ECE/TRANS/WP.29/2007/20
8 December 2006

**AMENDMENTS TO THE PROPOSAL FOR 04 SERIES OF AMENDMENTS TO
REGULATION No. 48**

(Installation of lighting and light-signalling devices)

Submitted by the representative of the European Community

Model A

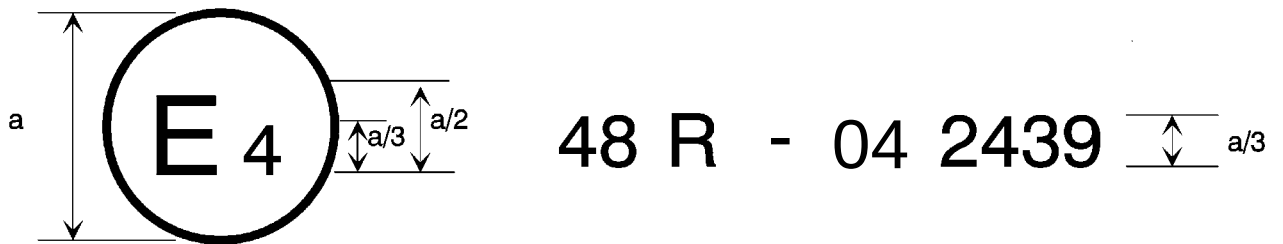
Annex 2, amend to read:

The above approval mark affixed to a vehicle shows that the vehicle type concerned has, with regard to the installation of lighting and light-signalling devices, been approved in the Netherlands (E4) pursuant to Regulation No. 48 as amended by the 04 series of amendments. The approval number indicates that the approval was granted in accordance with the requirements of Regulation No. 48 as amended by the 04 series of amendments.
